**REMARKS**

This case has been carefully reviewed and analyzed in view of the Official Action dated February 9, 2005.

FIG. 4

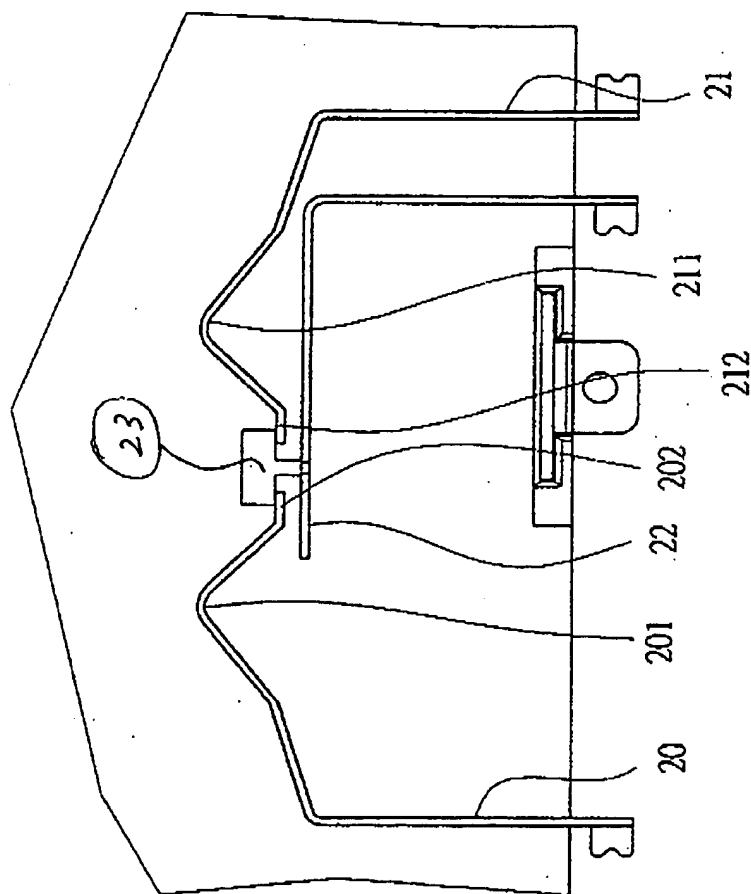
The Examiner has objected to the drawings because they do not include reference sign(s) mentioned in the description. Further, the Examiner has objected to the drawings under 37 CFR 1.83(a). Replacement sheets of the drawings for FIGS. 4 and 7 are submitted for the Examiner's approval and the specification has been amended to overcome the objections.
